BRAUM'S ADDITION

SITE PLAN TO SERVE
BRAUM'S ICE CREAM STORE
ROCKWALL, TEXAS

I have had an opportunity to review the draft site plan for the Braum's location at Yellowjacket and SH-205 and there are some areas that need to be addressed. My comments are as follows:

Agenda Item: P&Z 91-20/SP/FP/CUP - Hold Public Hearing and Consider Recommending Approval of a Request from Braum's for a Conditional Use Permit for a Structure with Less than 90% Exterior Masonry Facade, a Site Plan and Final Plat on a Tract of land Located on Yellowjacket and SH-205

NOTES FOR BRAUM'S CONT'D.

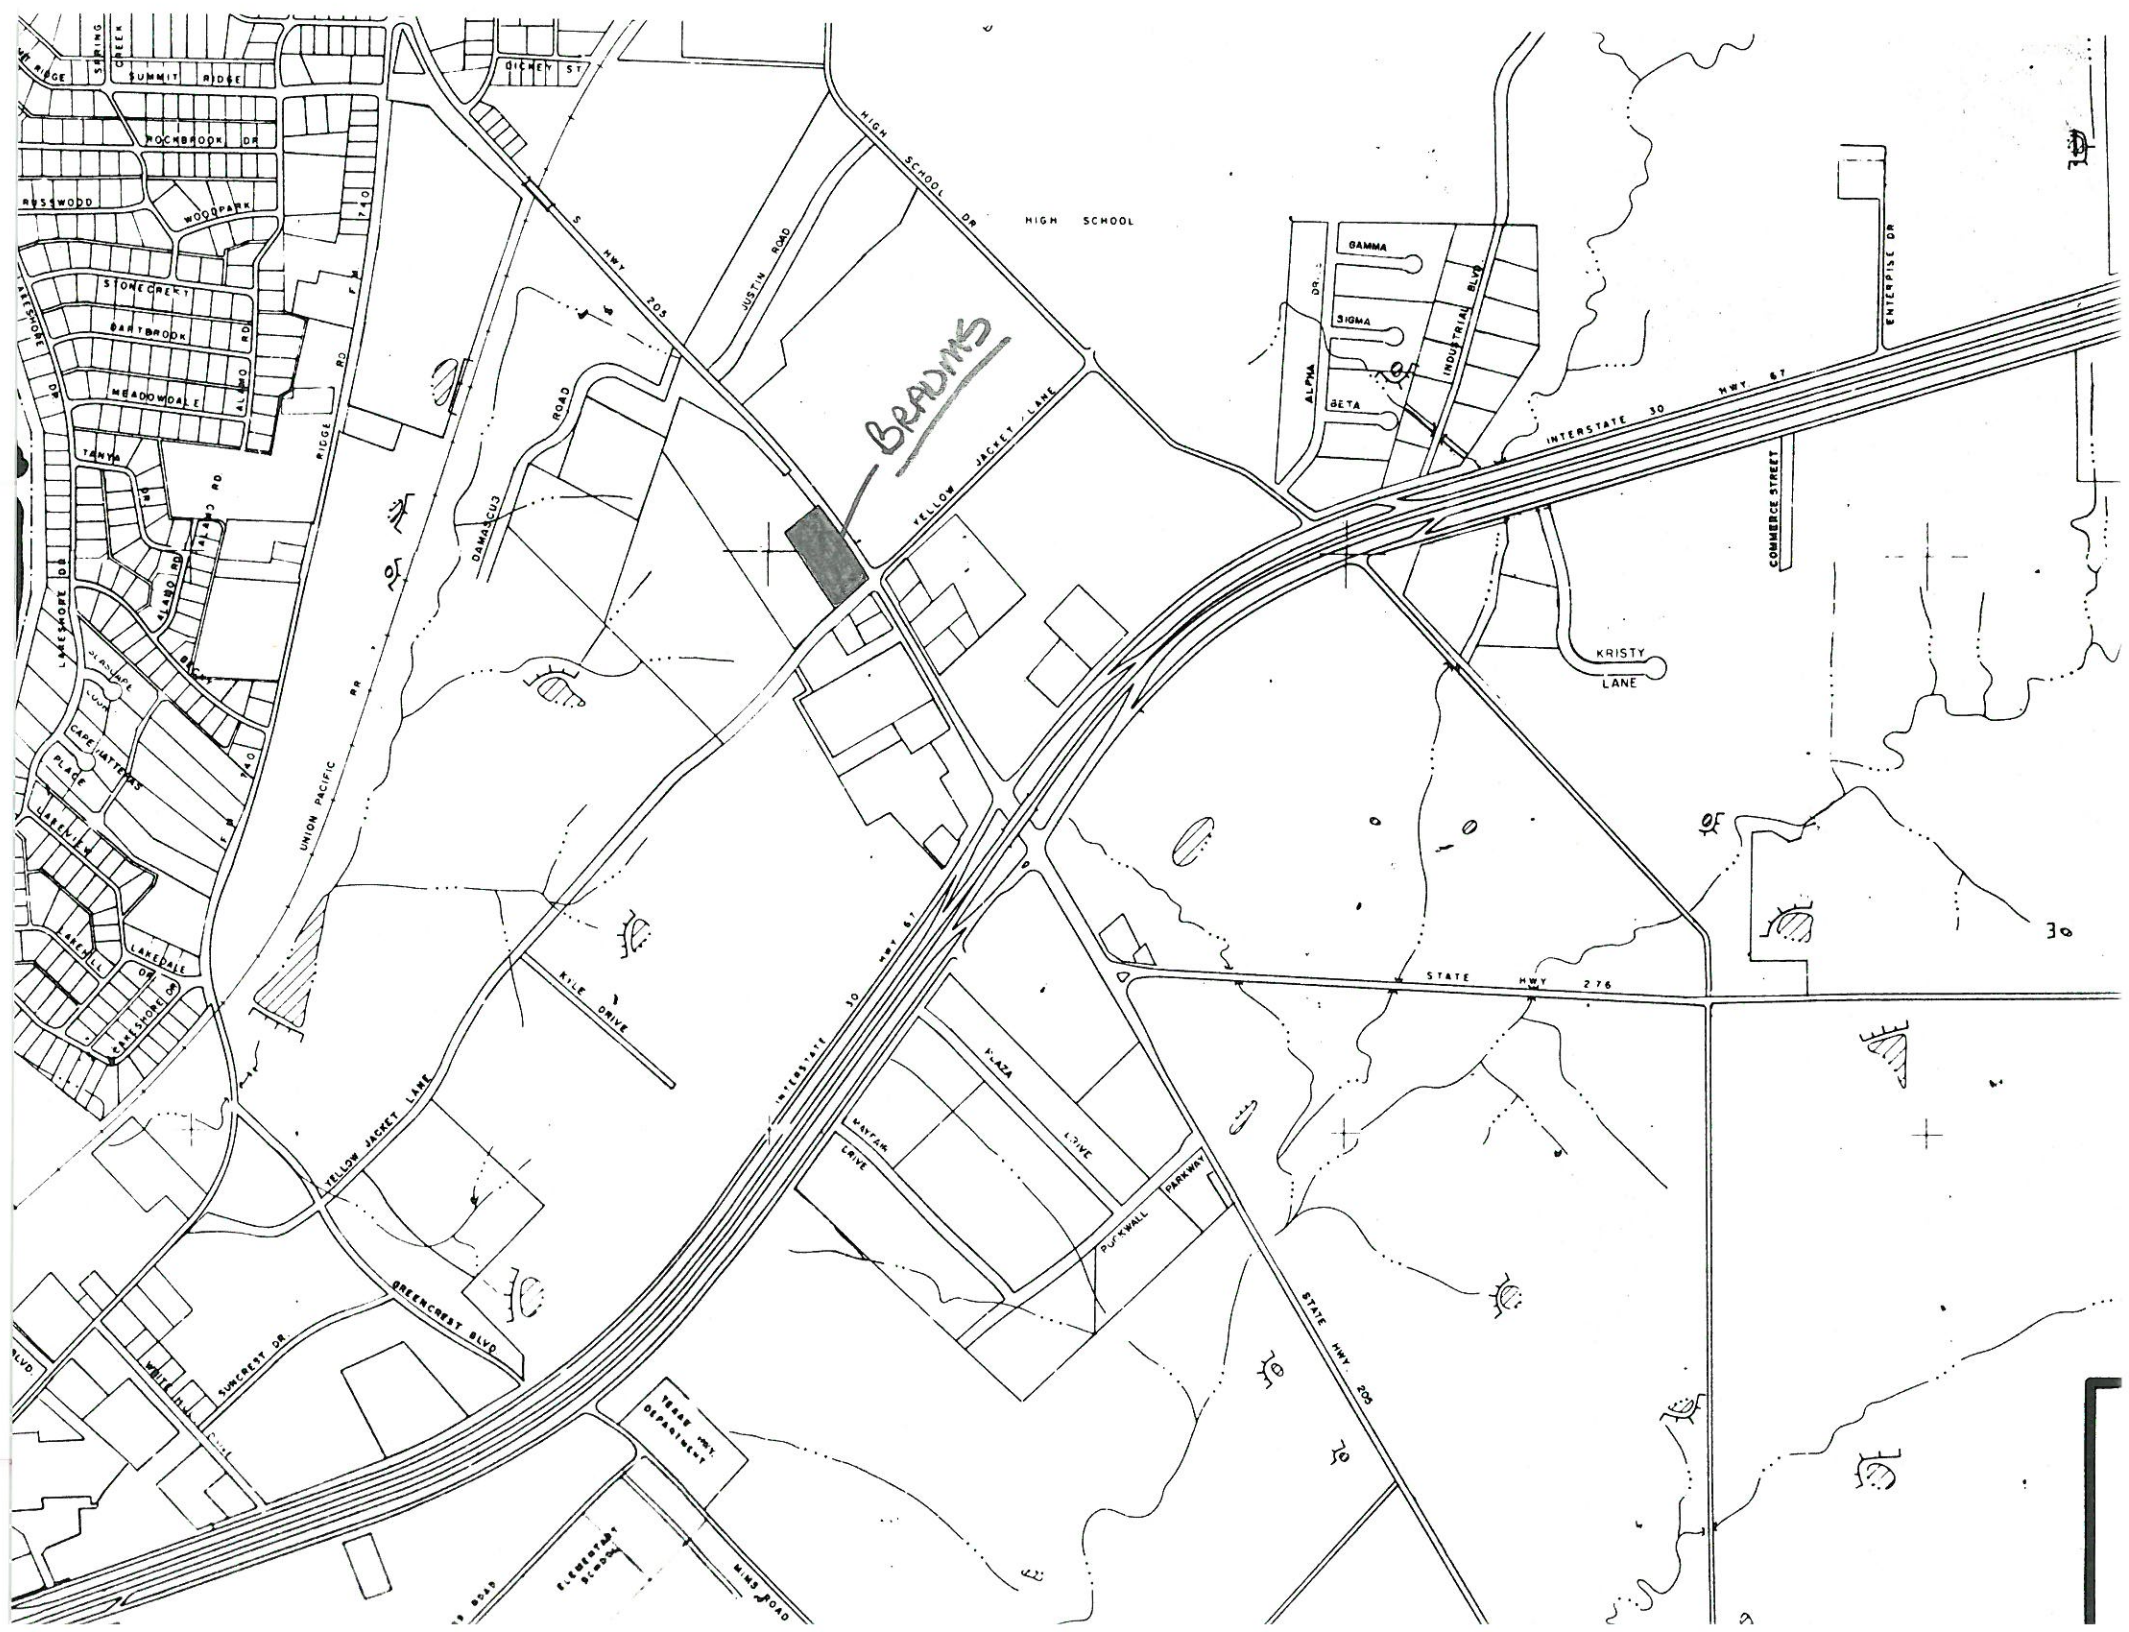
Building Location - The building and the angle parking along the south property line are too close together for two way traffic. This drive would need to be signed as one way.

1. The two entrances onto SH-205 are located approximately 150 feet apart. Our current standards require that drives be located at least 200 feet apart unless a waiver is granted. It was pointed out that when SH-205 is widened there is no median opening planned for this site.
2. It was recommended that the entrance off of Yellowjacket be reduced from 40 feet. As shown the outside radius of this entrance will conflict with the radius of the adjacent driveway into the apartments. Again, there is no median opening planned for this area when the road is widened to a 4 lane divided section.
